SERVICE INSTRUCTION M20-88A
Date: December 14, 2016

SUBJECT: STABILIZER TRIM STOP/SCREW MODIFICATION

MODELS/ SN Mooney Aircraft M20J Serial Numbers 24-0001 thru 24-1694 & 24-3000 thru 24-3172
AFFECTED: Mooney Aircraft M20K Serial Numbers 25-0001 thru 25-1230
Mooney Aircraft M20L Serial Numbers 26-0001 thru 26-0041
Mooney Aircraft M20M Serial Numbers 27-0001 thru 27-0058TIME OF COMPLIANCE: **WITHIN THE NEXT 100 FLIGHT HOURS**

INTRODUCTION: This Revision Supersedes M20-88 Dated 5/1/1990

Figure SI M20-88-1

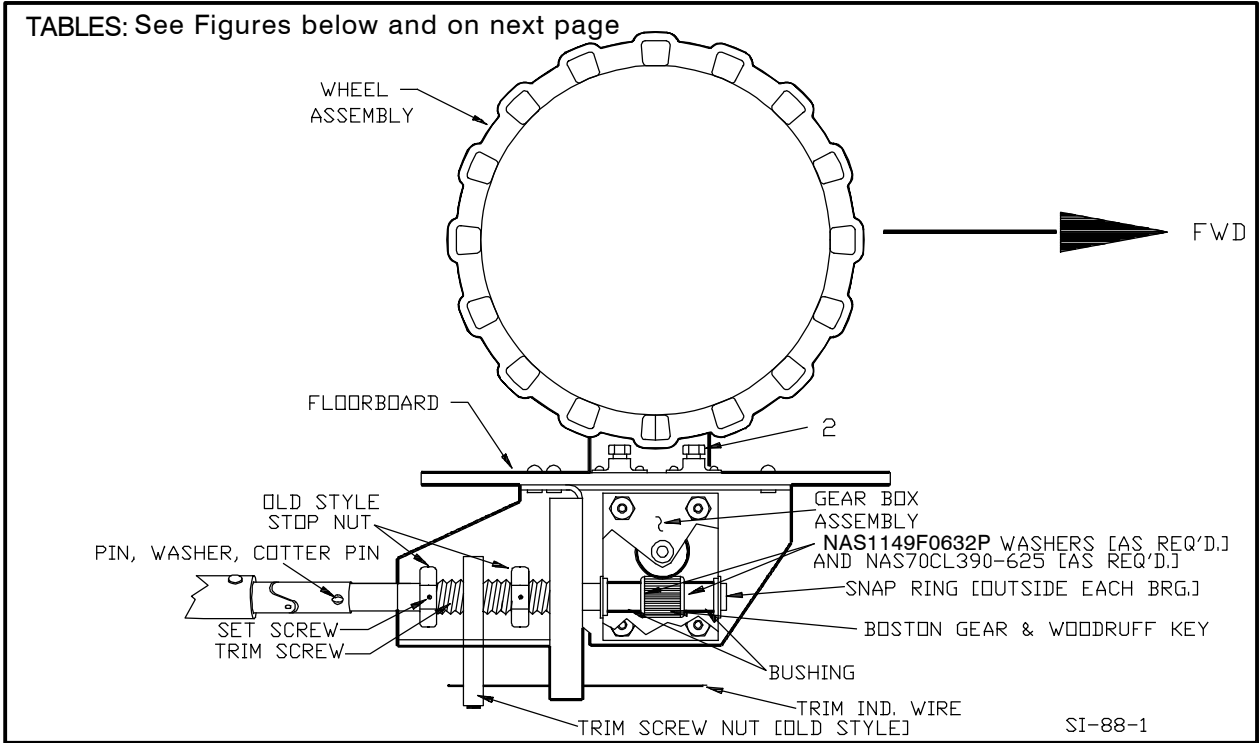
There have been occasions when the elevator trim control wheel has been manually turned to the extreme nose up or nose down condition and the electric trim system was unable to move the trim indicator nut off the stop at the next electrically activated command. Manual movement must be the initial action to get the trim indicator nut off the stop, then the electrical system will operate normally.

4. Remove cotter pin, washer and pin that secures trim tube universal joint to trim screw (Figure SI M20-88-1).
5. Loosen gear box bolts (Index 1, Figure SI M20-88-2) if not already done, and both NAS428-3-4 bolts (Index 2, Figure SI M20-88-2) to give slack in roller chain between upper and lower sprocket of trim control wheel assembly.

7. Remove roll pin, P/N RPA52-028-125-1125 holding lower sprocket, P/N 740049, to gear box shaft. Remove sprocket.
8. Loosen set screw, #6-32 x 1/8, in each existing trim stop so they will unscrew easily. Remove aft trim stop (DN stop) from trim screw (Fig. SI M20-88-1).

12. Measure and document longitudinal free play in trim screw shaft (end play) as assembled in the gear box assembly.
13. Remove forward snap ring from trim screw. Reference Figure SI M20-88-1
14. Lightly tap trim screw at forward end, with a plastic mallet, to drive trim screw, bushings, washers, gear and aft bearing from gear box assembly housing. Bearings are installed with loctite (Blue) at assembly, so some effort may be required to break it loose. **DO NOT DAMAGE BEARING OR HEATING THE HOUSING.**
15. When existing trim screw, and components attached to it, comes free from gear box housing, the bushings, washers, gears, woodruff key, snap ring and aft bearing will be removed. Retain components, except woodruff key, to place back on new trim screw (Fig. SI M20-88-1).

20. Measure longitudinal free (end play) of assembled trim screw to ensure that free (end play) does not exceed 0.010” Total Indicator Reading (TIR).
21. Add NAS70CL390-625, shim washer(s) under NAS1149F0632P washer or under either snap ring as needed to maintain 0.010” TIR free (end play). Trim screw assembly will require removal from gear box housing again if shims are required under NAS1149F0632P washer(s).

Figure SI M20-88-2

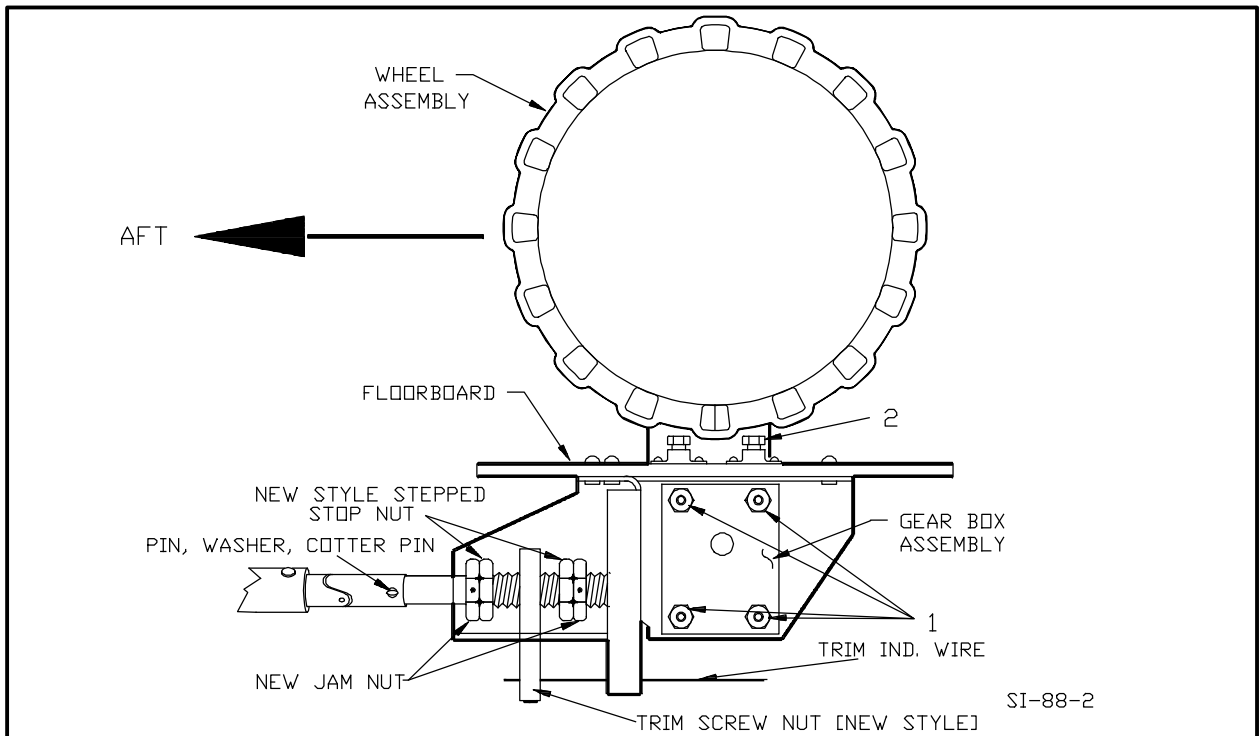
1. Remove belly access panels or smooth belly fairing to gain access to lower side of the trim control wheel assembly.
2. Remove trim indicator wire from trim screw nut by loosening set screw(s) that restrain trim wire.
3. Remove any brackets connected to gear box bolts (Index 1, Figure SI M20-88-2) both sides if required. Different models have different type of brackets.

22. Install one jam nut (UP stop side), P/N 740086-003 (M20J) or 740086-001 (M20K, M20L or M20M), on trim screw. Screw toward gear box housing leaving approximately 0.375 inch gap on threads between gear box and jam nut (Figure SI M20-88-2).
23. Install one stepped stop nut (UP stop), P/N 740086-007 (M20J) or 740086-005 (M20K, M20L or M20M) on trim screw. Screw toward gear box housing and against jam nut installed in step 22.

24. Position gear box/trim screw assembly to lower trim wheel assembly so new trim indicator nut, P/N 740086-011 (M20J) or 740086-009 (M20K, M20L or M20M) can be placed on trim screw and screwed in place to proper position within slotted bracket area. This is the reverse of Steps 9 & 10.
25. Install other stepped stop nut (DN stop) (stepped side toward trim indicator nut) on trim screw.
26. Install other jam nut on trim screw against stop nut (DN stop).
27. Reverse Steps 2 thru 7 to reposition gear box assembly back on trim wheel assembly. Do not tighten trim indicator wire set screw at this time. Position all other brackets but do not tighten bolts holding gear box assembly to trim wheel assembly (Fig. SI M20-88-2).
